## Field Safety Notice

Philips MR systems with MR Elastography (MRE)  
Potential for inaccurate (lower) liver stiffness measurements

April 2026

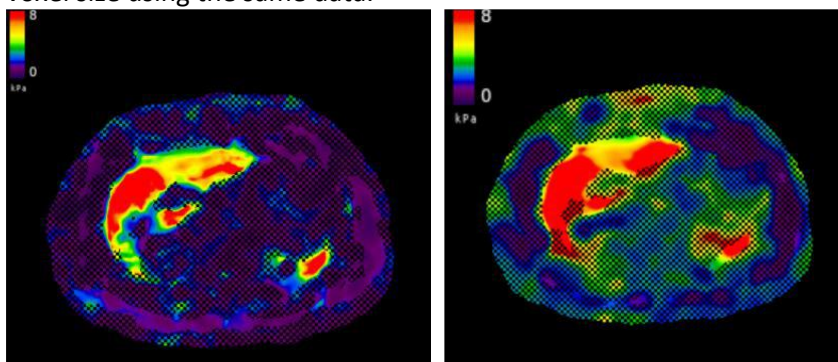
Philips has become aware through the MRE software system developer Resoundant about an issue affecting MRE stiffness measurements when a specific range of image reconstruction parameters is used in combination with Resoundant's algorithm. Specifically, the reconstruction voxel size settings in the default MRE scan protocol are too small, which can potentially lead to inaccurate liver stiffness measurements (lower values). See Figure 1.

1. Perform one of the following:
  - If you have an existing MRE ExamCard, add it to the ScanList
  - If you are creating a new MRE ExamCard:
    - a. With an ExamCard in the ScanList, select **Add New Protocol item**.
    - b. Navigate to the required MRE protocol from the **Philips\Abdomen\Liver\Specials** folder (refer to Figure 2 above)
    - c. Add the MRE protocol to the ScanList.
2. Double-click the MRE protocol to edit it.
3. On the Geometry tab make the following changes:
  - Change the **FOV RL** to 480 mm
  - Change the **Recon voxel size RL** to 1.5mm
  - Accept the changes

Figure 4. Updated MRE protocol settings in the Geometry tab

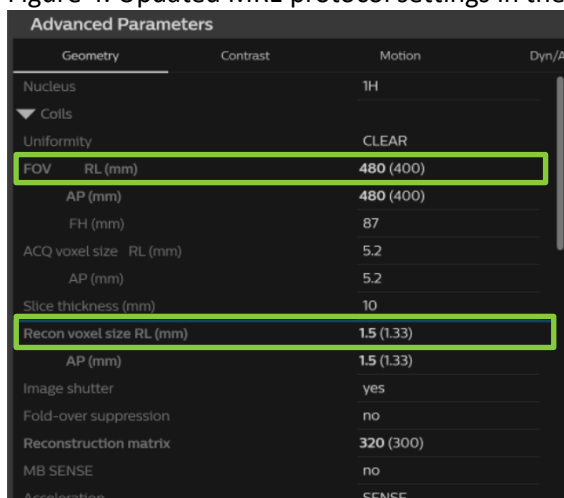
- On the Geometry tab make the following changes
  - Change the **FOV RL** to 480 mm
  - Change the **Recon voxel size RL** to 1.5mm
  - Accept the changes
  - NOTE:** For the FFE\_MRE\_4sl protocol on Release 12 systems, it may be necessary to re-enter the Recon voxel size RL of 1.5mm if the system defaults to 1.48mm.
